Staff Report

Re: Petition PLNHLC2017-00722, TAG Row House Development

NEW CONSTRUCTION – 3-UNIT ROW HOUSE

PROPERTY ADDRESS: 613 East 100 South

SITE PLAN

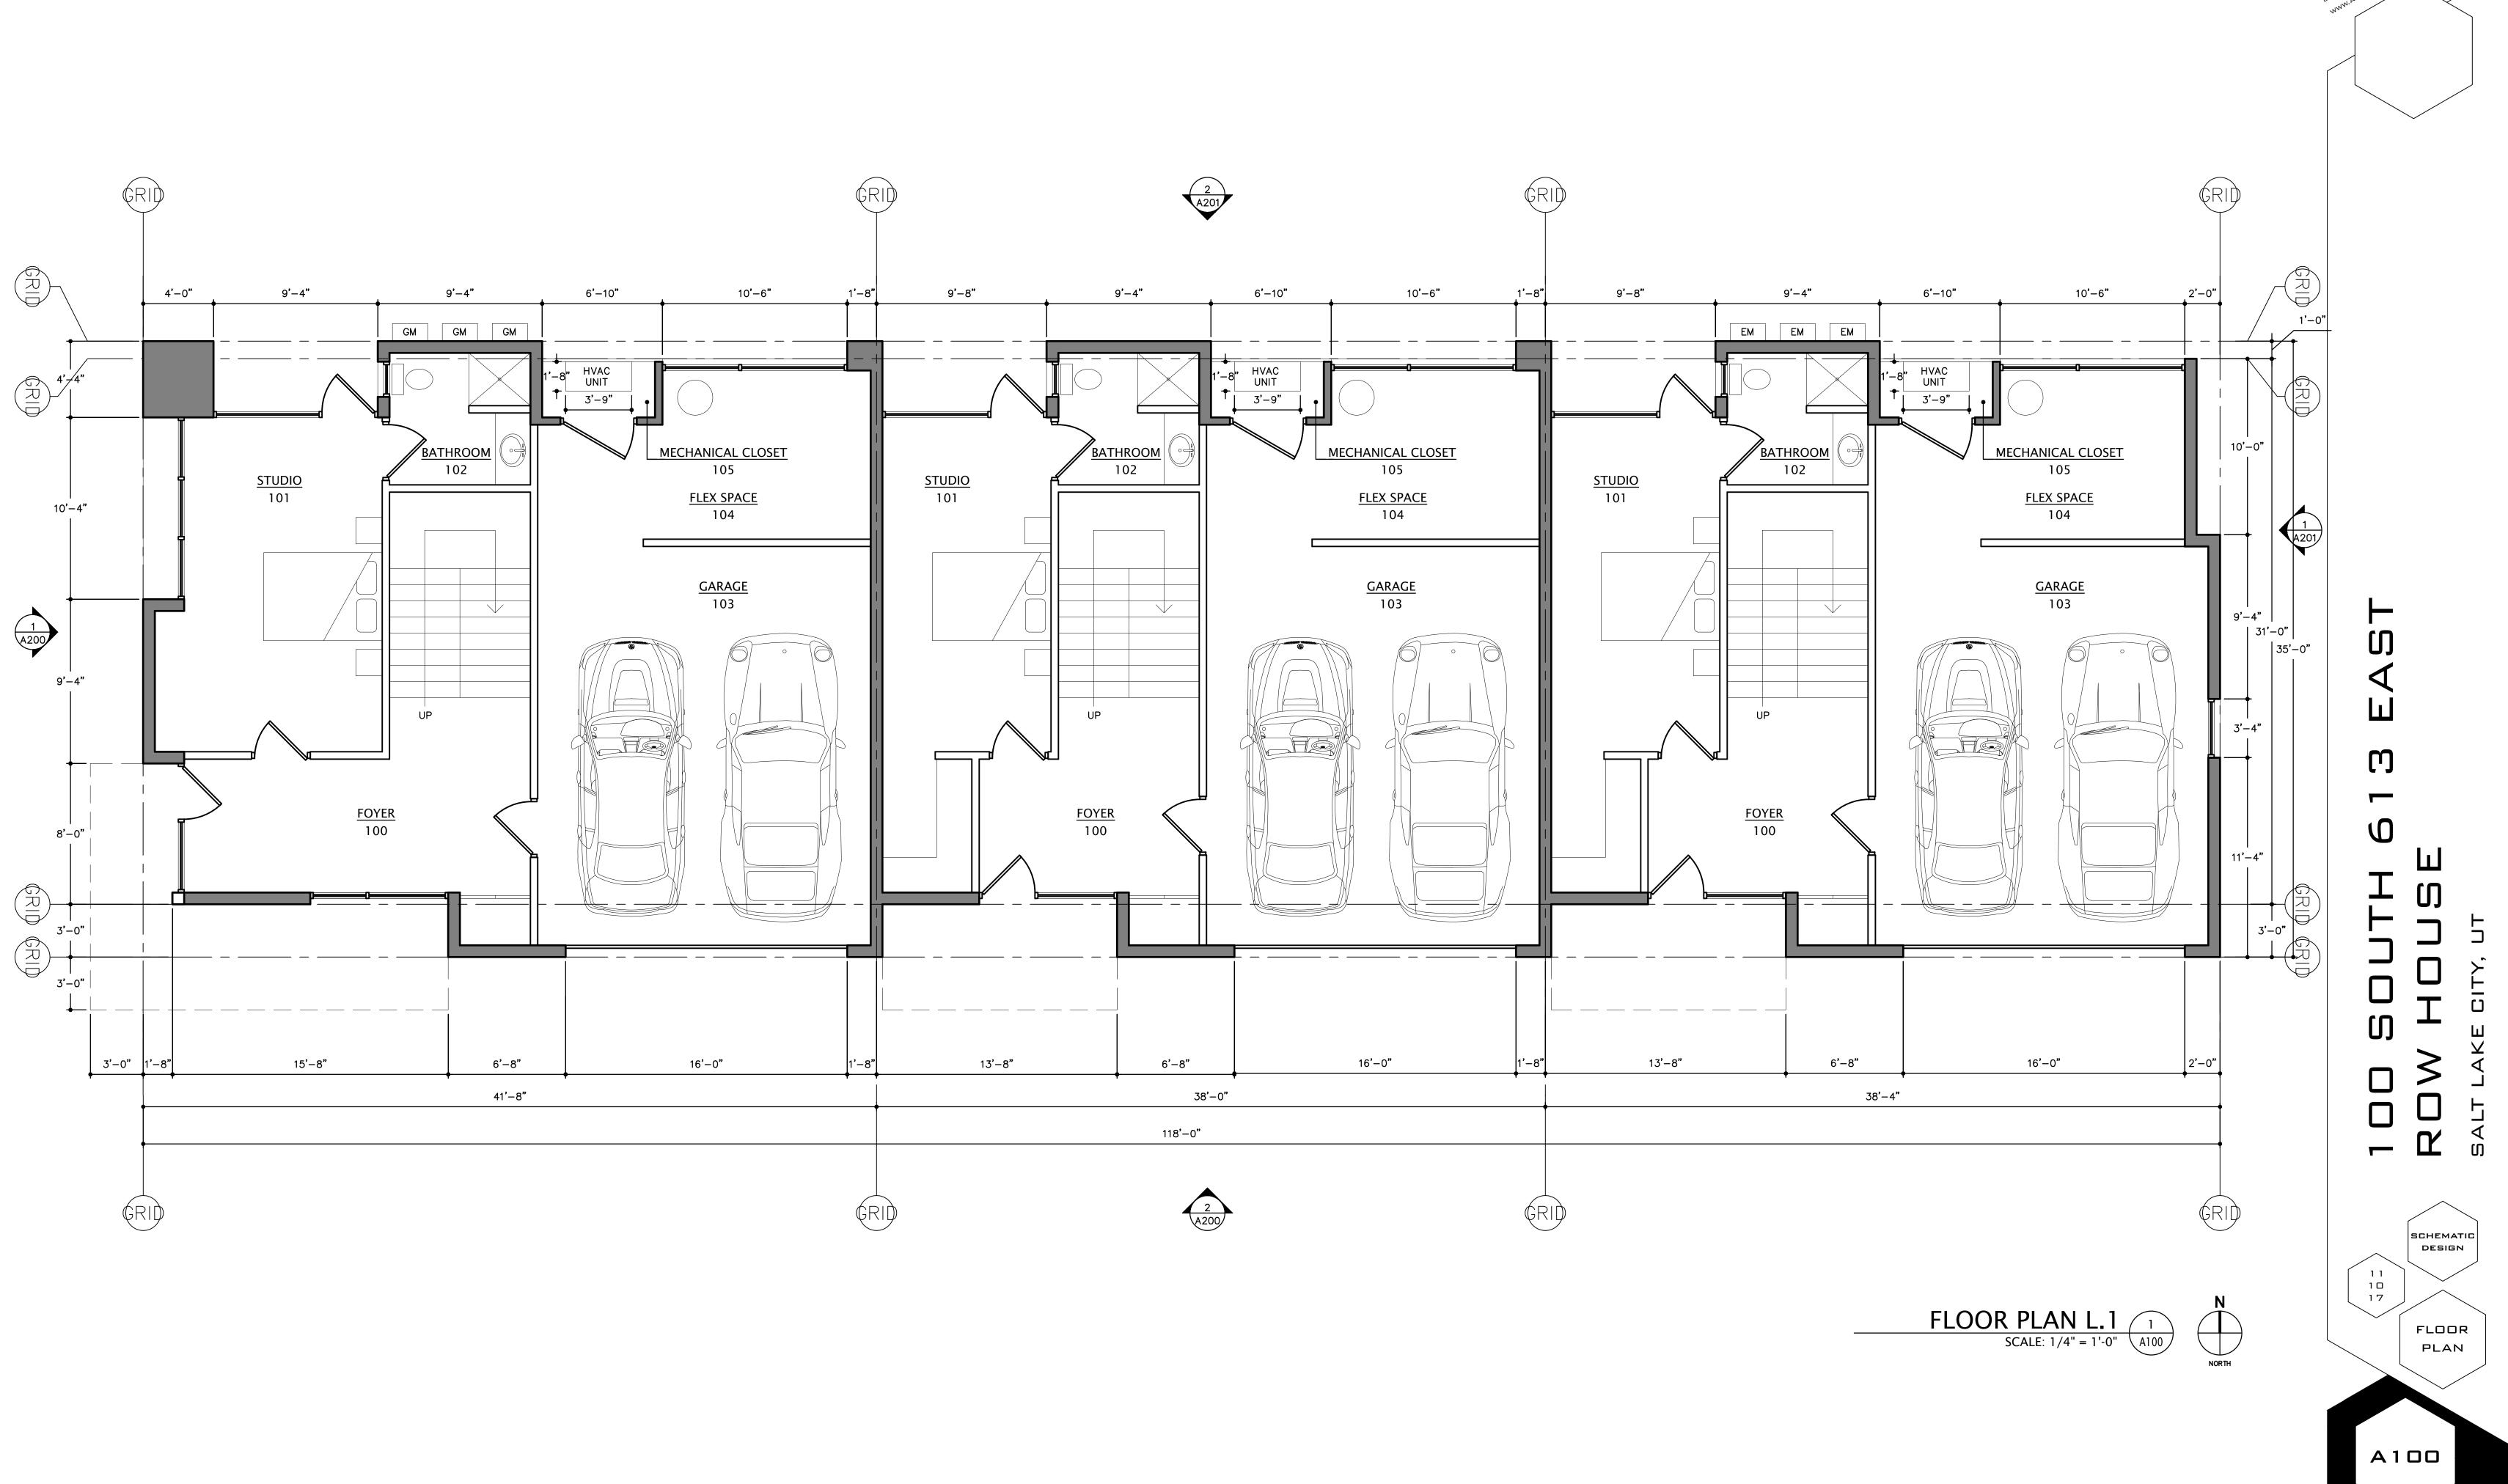
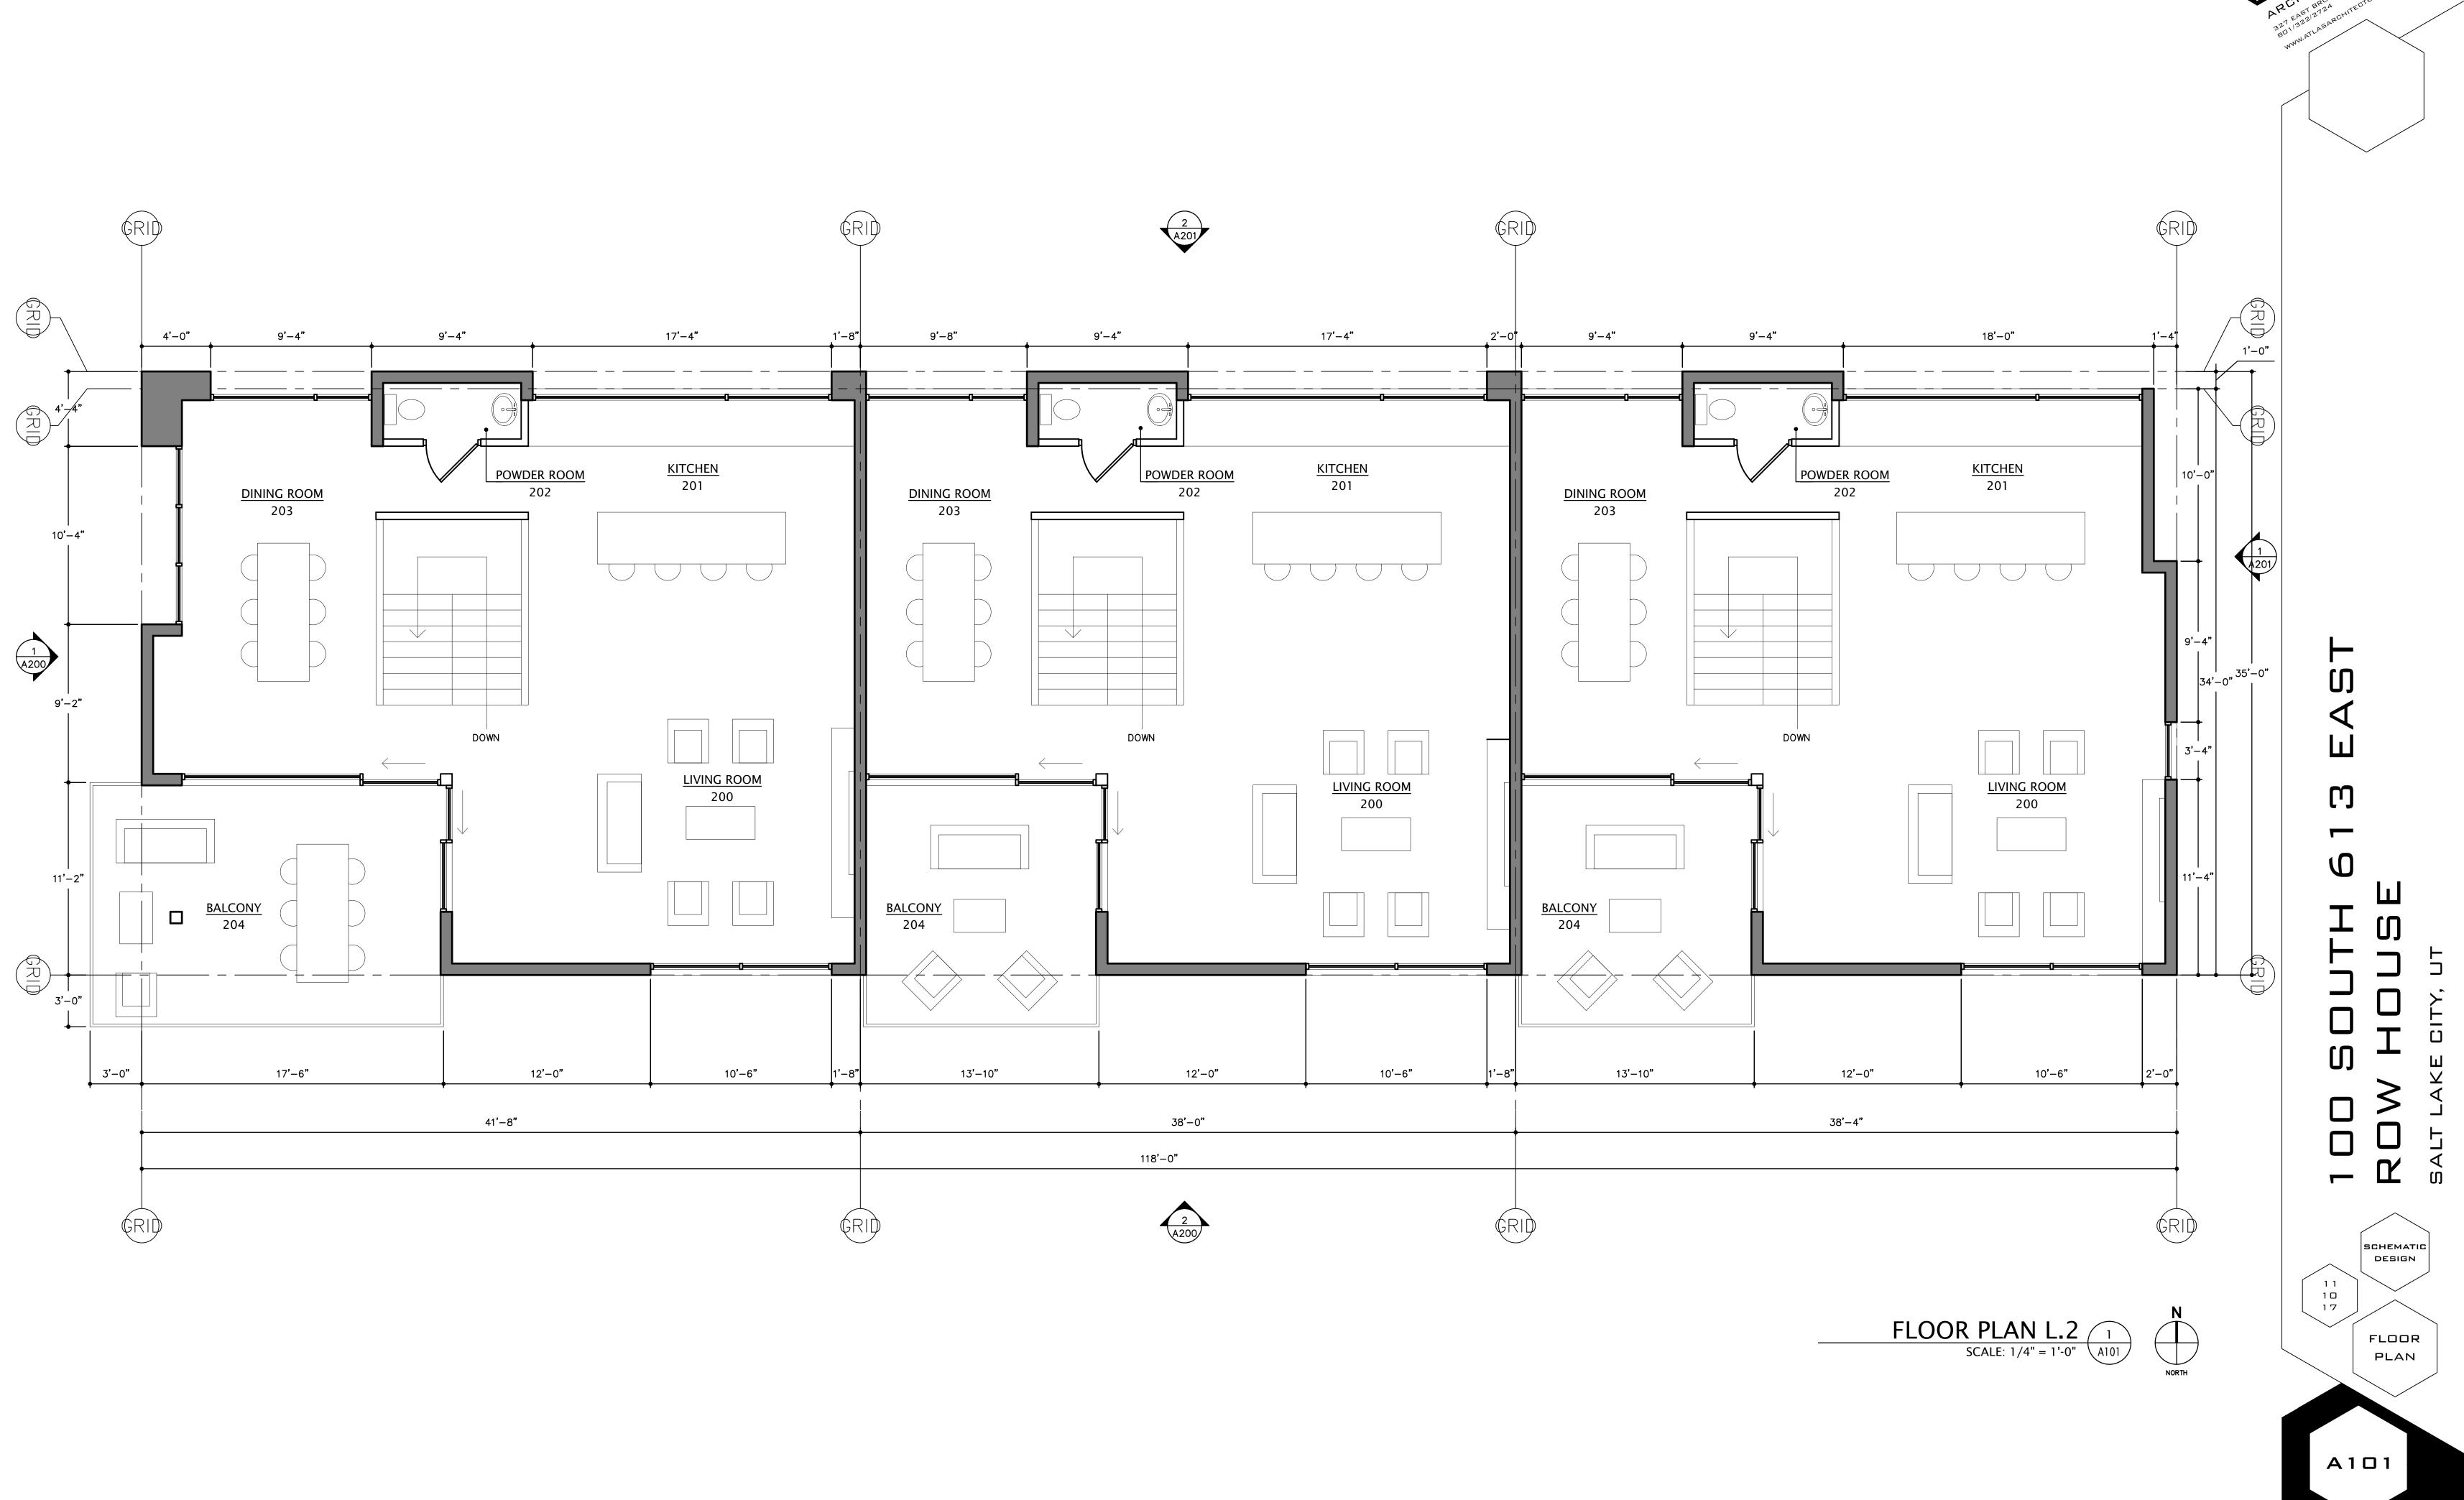
- 1. The building has been pushed back so that the balconies are meeting the front yard setback. (Refer to sheet A002.)
- 2. The current driveway is 19' feet wide. To accommodate Section 21A.24.010(H) landscaping is being provided along the east property line (Image B). We are coordinating with the neighbor to the east (Parcel 227-016) to allow for a series of shrubs to be planted along their side of the property which will provide adequate landscaping and a natural barrier between the two neighboring properties. (Refer to sheet A002.)
- 3. The AC units are not located closer than 4 feet to the property line. They will be enclosed in a dedicated mechanical closet and they will be completely out of site. (Refer to mechanical equipment cut sheet, A100 "Mechanical Closet #105")

- Recessed walls have been carried out on west facade. (Refer to A000 & A201)
- Landscaping has been installed along the south, east & west side of the property.
 (Refer to A002)

• A landscape plan has been provided and contains more landscaping on the east and west sides of the building to act as a buffer between the neighboring properties (Image A & B). An existing retaining wall and fence will be used on the west elevation (Image A) and will be enhanced by new shrubs for landscaping. Along the east property line an existing stone retaining wall (Image B) along with a new retaining wall will be used. These retaining walls will be lined with a series of shrubs to provide adequate landscaping and a natural barrier between the two neighboring properties (Image C).

• The size and dimensions of the balconies' footprints has been labeled. The balconies protrude 3'-0" from the building and the south face of the balcony meet the front yard setback. (Refer to A002, A100, A101 & A102) As discussed during our review meeting a balcony detail will not be required at this time.

• The back patios have been dimensioned. The intent of the space is to serve as an entry path and landing for the second entry to the home. The patios and steps along the west elevation will be built of concrete. The steps and their respective elevations have been indicated on the site plan. Their purpose is to create a path to the home's second entry as there exists a natural change in grade. We have designed the site work so as to mitigate impact on the existing topography. (Refer to A002).

The location of the trash & recycling receptacles has been indicated on the site plan. The receptacles will be screened as described on the site plan. (Refer to A002)
